PIP5395B Ticking Rattle Or Buzz Noise Heard The Best In The Passenger Compartment

Supersession Statement

This PI was superseded to update Recommendation/Instructions. Please discard PIP5395A.
The following diagnosis might be helpful if the vehicle exhibits the symptom(s) described in this PI.

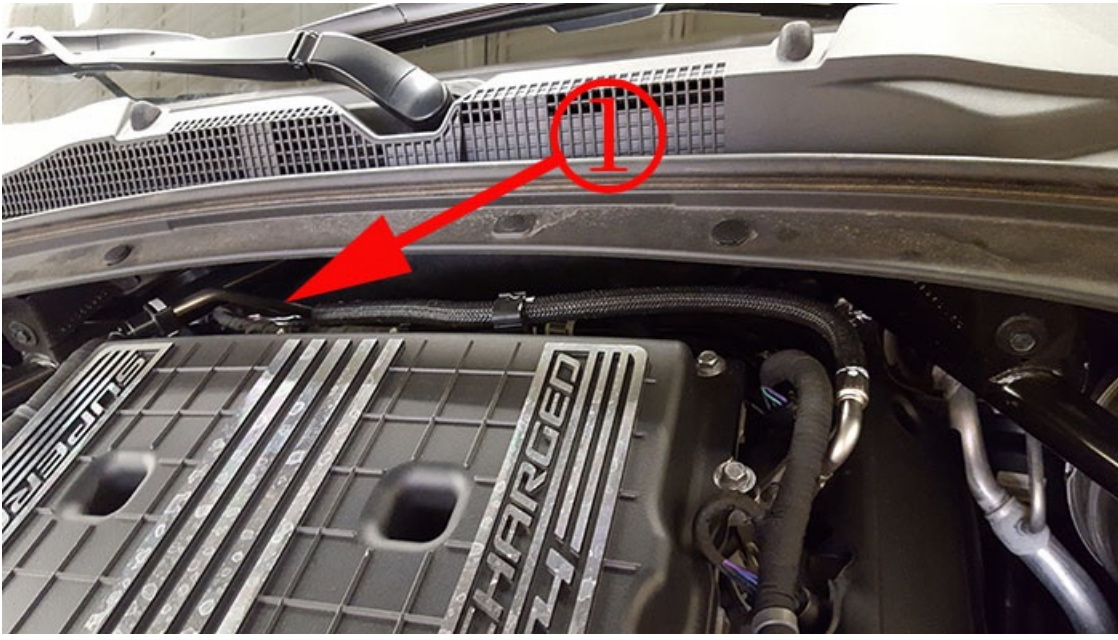
A customer concern of rattle or ticking noise that is louder inside the vehicle than outside.
The noise may be picked up at the back of the left valve cover.
The noise may also sound like a lifter tick.
This may also be called a fuel line buzz or ringing noise.

Listen to the fuel line connection at the left side of the engine.
If the noise is heard best at the fuel line (this sound will be real loud with a stethoscope).
The fuel feed line between the high pressure fuel pump and chassis fuel line could be the cause allowing high pressure pulsation back to the low side of the fuel system. There is not a good way to test the check valve, the line will need to be replaced.
On pickups and SUVs, a vibration in the fuel line at the fuel tank may also be observed.
Reevaluate the concern.
There are two different fuel line types that contain this check valve and vary by model.

The line above is the fuel feed pipe for Corvette, truck and SUV.
This line connects the chassis fuel line to the high pressure fuel pump.

These pictures above shows the chassis fuel feed pipe for the LT4 supercharged ZL1 Camaro. On LT1 Camaro and LT4 CTS-V this line would have a jumper line with quick disconnects at both ends. One end will connect to the chassis line and the other to the high pressure pump feed line.
